Work Order ID 160697

Item Name: Cable Assembly

DART SERVICE INSTRUCTION

TO AMEND IIN-D412-704 REV. C OR EARLIER
AND ICA-D412-704 REV. 4 OR EARLIER
REF CANADIAN STC SH93-34
REF FAA STC SR00957NY
REF EASA STC EASA.IM.R.00696

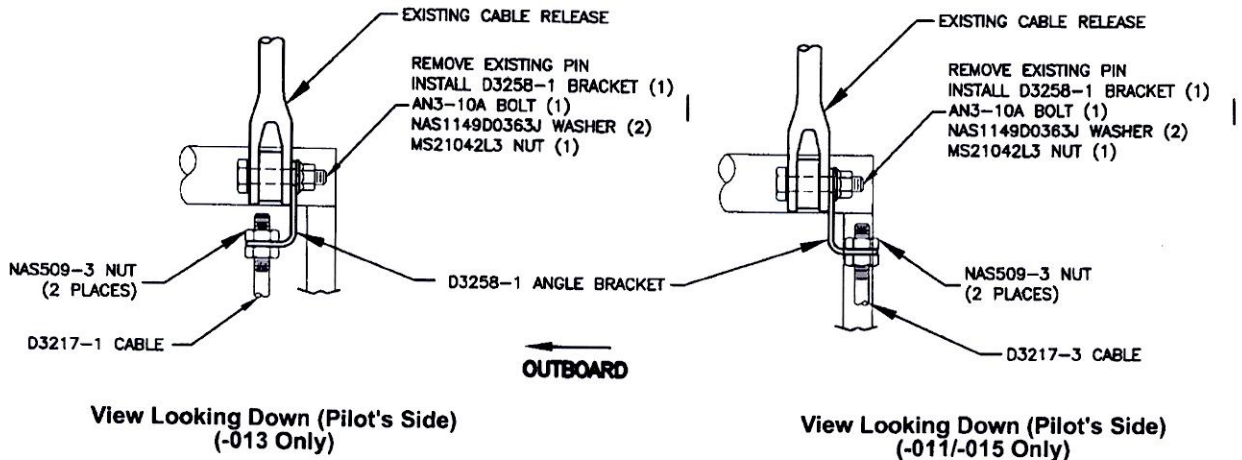
The purpose of this Dart Service Instruction is to correct part number error in Installations Instruction IIN-D412-704 Rev. C or earlier and Instructions for Continued Airworthiness ICA-D412-704 Rev. 4 or earlier. The AN3-13A bolt should be replaced with an AN3-10A bolt in Figure 5 - Detail L in IIN-D412-704 and Figure 25-4 Detail L in ICA-D412-704. See sheet 2.

Figure 5 - Detail L or Figure 25-4 - Detail L

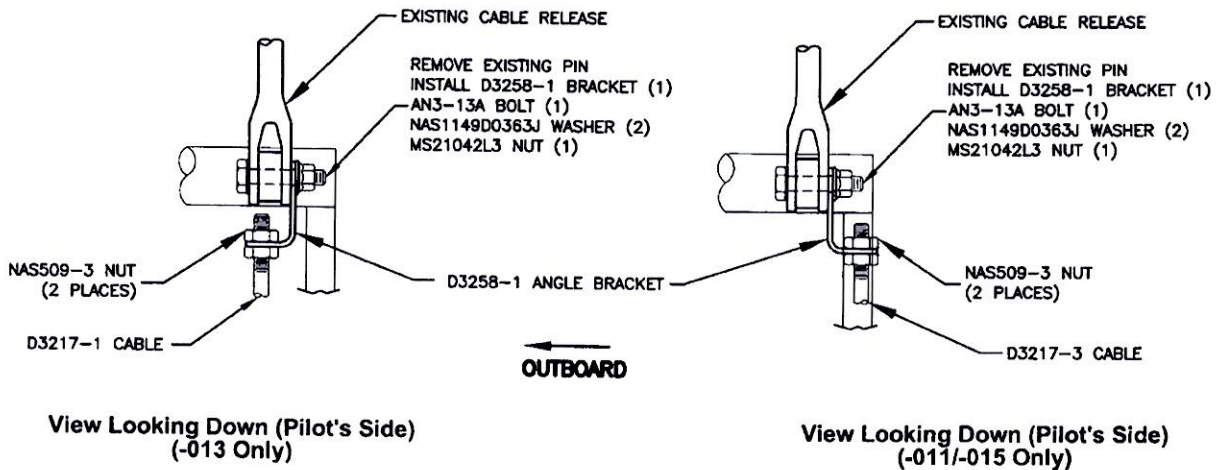
Revise Detail L Figure 5 of IIN-D412-704 and Detail L Figure 25-4 of ICA-D412-704 as follows:

NOW

WAS
